Rezoning Transportation Analysis

Petition Number: 2018-013

General Location Identifier: 04733106, 04733107

Date	Description
02-20-2018	First Review
03-20-2018	Second Review

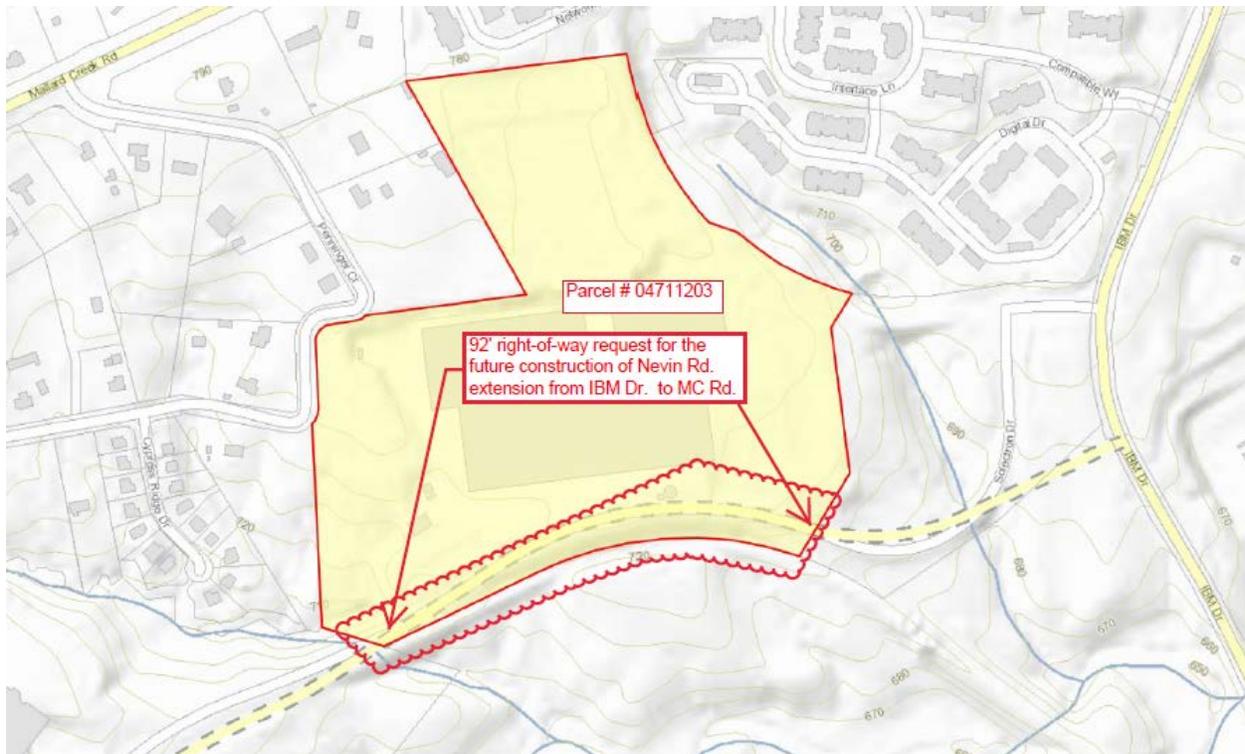
- ~~1. Traffic Study A Traffic Impact Study/Transportation Technical Memorandum is not needed for the complete review of this petition.~~
- ~~2. The petitioner should revise the site plan and conditional note(s) to remove transportation note B and call out two (2) new site access driveways along the proposed parking lot's Penninger Circle frontage.~~

While the rezoning site land use does not generate trips on its own, the expansion of the parking lot indicates additional vehicle trips are anticipated from nearby buildings (perhaps reuse). These access driveways are necessary to provide adequate traffic access/distribution entering/exiting to support the land use.
